CHARLESTON FIRE DEPARTMENT STATION #'S 1, 2, 4, 5 AND 8 RENOVATIONS

ADDENDUM #2

JUNE 25, 2025

THRASHER PROJECT #T60-11407

1 ADD #2 - DOOR TO GENERATOR ROOM 123
ADD 2-2 1/8" = 1'-0"

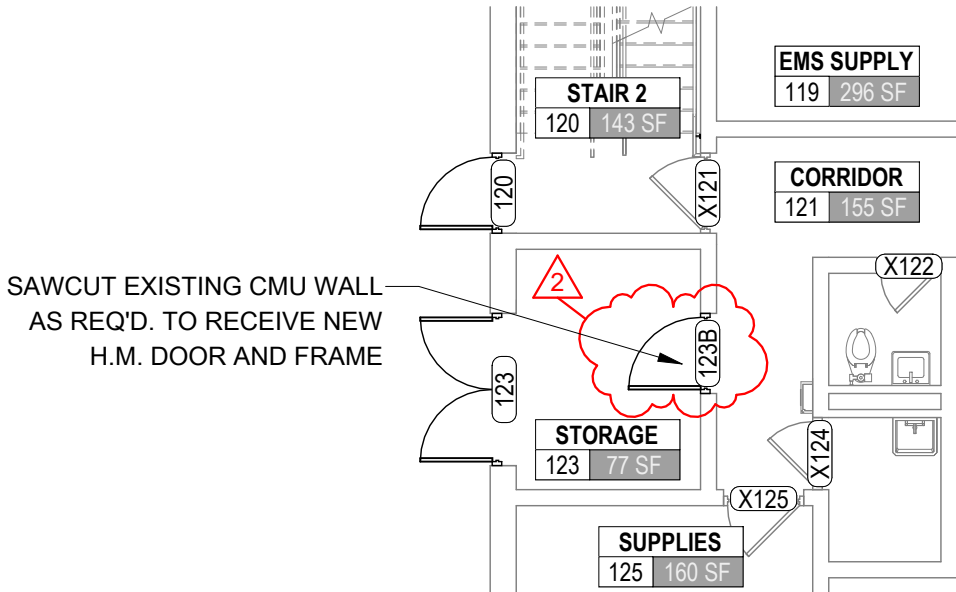
ADD: Drawing ADD 2-2 - NEW DOOR INTO EXISTING GENERATOR ROOM

REVISION SCHEDULE		
No.	DATE	DESCRIPTION
2	6/25/2025	NEW DOOR TO EXISTING GENERATOR ROOM.

#	DOOR					FRAME			HARDWARE	KEYROOM
	DOOR TYPE	WIDTH	HEIGHT	DOOR MATERIAL	DOOR FINISH	FRAME TYPE	FRAME MATERIAL	FRAME FINISH		
123B	F	3' - 0"	7' - 0"	H.M.	PAINT	2	H.M.	PAINT	25	121

HARDWARE GROUP NO. 25

QTY		DESCRIPTION	CATALOG NUMBER	FINISH	MFR
3	EA	HINGE	5BB1 4.5 X 4.5 (NRP AS REQUIRED)	652	IVE
1	EA	ENTRANCE/OFFICE LOCK	ND50TD SPA	626	SCH
1	EA	FSIC CORE	23-030	626	SCH
1	EA	OH STOP	90S	630	GLY
1	EA	MOP PLATE	8400 4" X 1" LDW B-CS	630	IVE
1	EA	GASKETING	SR64/65 OR 488 SEALS AS REQUIRED	BK	ZER
HDWE SUPPLIER/GC TO VERIFY COMPATIBILITY WITH EXISTING DOOR/FRAME FOR NEW HDWE
